## REACH HUB AT A. MARIO LOIEDERMAN MIDDLE SCHOOL

### MANDATORY REFERRAL NO. 2025021

COMPLETED: 1/16/2026

MCPB ITEM NO. 10

Figure 6 – Proposed Solar Energy Improvements

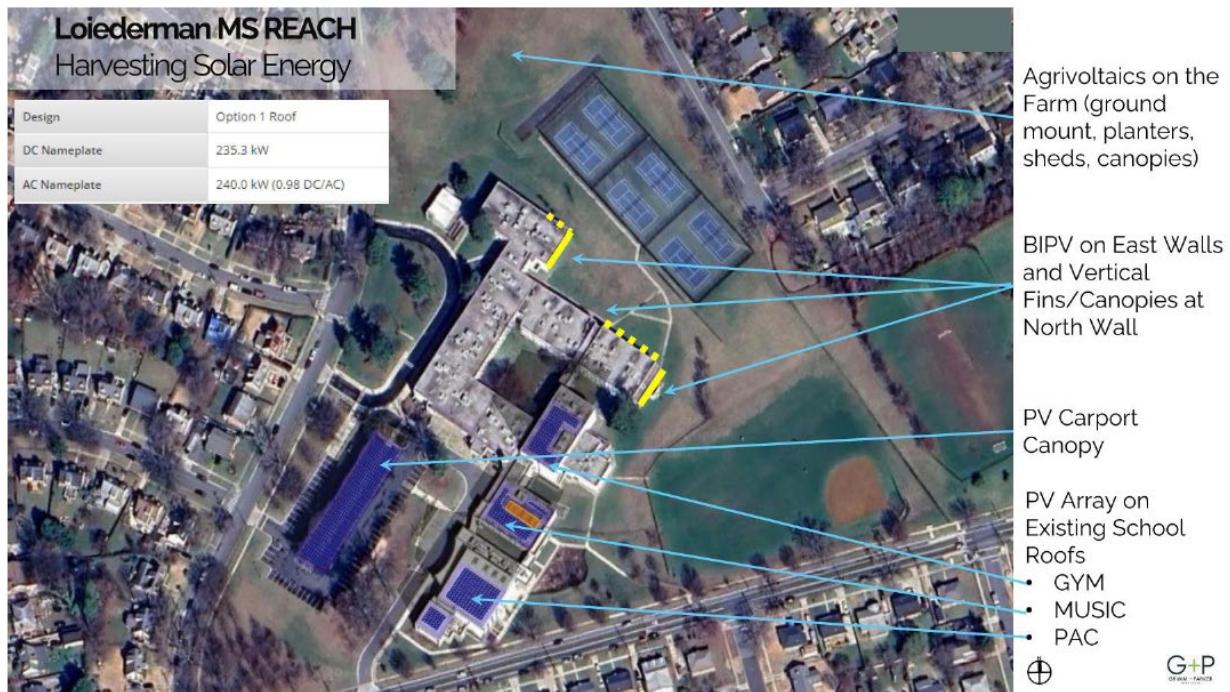
2. The Solar Collection System is recommended for removal within 12 months of the date when the use is discontinued or abandoned by the system owner or operator, or upon termination of the useful life of the system. A Solar Collection System is presumed to be discontinued or abandoned if no electricity is generated by the system for a period of 12 continuous months.

3. The Project is not proposing any lighting changes. Due to the extensive shading that occurs with solar panels, consider evaluating the addition or adjustment of lights for the main parking area to aid pedestrian circulation. These lights could be timed seasonally.
